## Main Hospital Pharmacy Pyxis Reconfigurations

**Project Number: 9557640**

**ADDENDUM NO. 1 dated July 16, 2024**

### REQUEST FOR PROPOSALS

Dimensional drawing

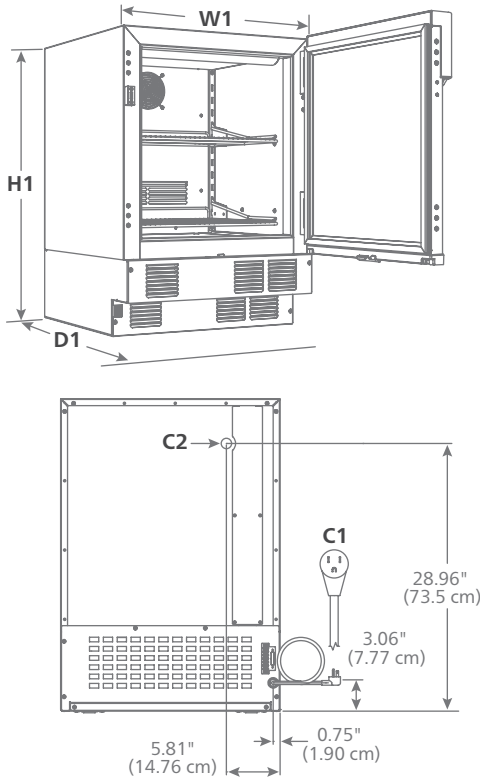
a.	Can you provide cut sheet on existing med refrigerators that will be reused?
b.	Will the refrigerators be relocated with the other Pyxis machines?
c.	The refrigerators did not appear to be seismically braced. Is seismic bracing for this equipment part of the DB scope?
	<b>Answer:</b>

a.	Typical existing med refrigerators on all floors; Follett FZR5P Performance Plus Undercounter Medical-Grade Freezers. See attached cut-sheets. Single 8th floor small refrigerator; Follett REF1 Medical Grade Countertop Refrigerator. See attached cut-sheets.

b.	Refrigerators relocation to be determined by Design Build Contractor. Relocate as required for Pyxis equipment replacement.
c.	Refrigerators are not intended to be part of this scope. Minimize replacement scope.
7	<b>Question:</b>
	Is there a service elevator that serves the tower or should bidders expect to use the passenger elevator?
	<b>Answer:</b>
	Service elevator is available for bidder use.
8	<b>Question:</b>
	Can the site accommodate 1-2 storage containers to be utilized as a laydown area?
	<b>Answer:</b>
